PR#: PR-51
FRN#: 78FR56775
NRC DOCKET#: NRC-2012-0246
SECY DOCKET DATE: 12/20/13
TITLE: Waste Confidence—Continued Storage of Spent Nuclear Fuel
COMMENT#: 00693

Re: Submission of Comments Concerning
Draft Waste Confidence Generic Environmental Impact Statement
and Proposed Rule
Docket No. NRC-2012-0246

Site-Specific Impacts Related to On-Site
Storage of Spent Nuclear Fuel at the
Indian Point Facilities, Westchester
County, NY

Figure 2: Population and wind rose for the Indian Point site. LEFT - Population by grid element (darker colors represent higher population) (ML13073A555 at p. 2-7), RIGHT – Wind rose for years 1999-2002 (ML12334A743).

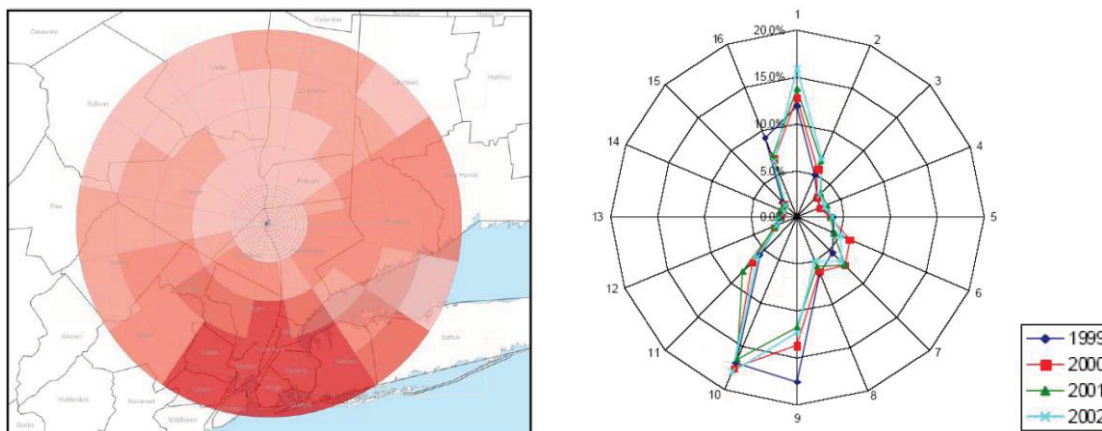
The wind rose (i.e., probability of wind directions) of the site has a direct correlation to the probability of certain areas being contaminated in the event of a severe accident and thus requiring mitigative actions. In the Consequence Study, the reference plant Peach Bottom's wind rose was such that the predominant wind directions were towards lower population areas (US-NRC 2013b, Section A.2). By comparison, the predominant wind directions at the Indian Point site are to the North/North-Northwest and to the South; the latter would affect the New York City metropolitan area, one of the most populated areas in the U.S (see Figure 2 below, showing the highest population concentrations surrounding Indian Point and the wind rose).

Because many plants are located in low population areas, Peach Bottom’s population may be representative of some plants. Given the combination of Indian Point’s population and predominate wind direction, the results of US-NRC’s Peach Bottom analysis are not applicable to Indian Point. As shown in Figure 3 below, the population density within 50 miles of the Indian Point site is far greater than even those considered in the Consequence Study’s sensitivity analysis.⁷ With the combination of higher population and a dominant wind direction toward the most populated areas, it is reasonable to expect that the consequences to the public surrounding Indian Point may
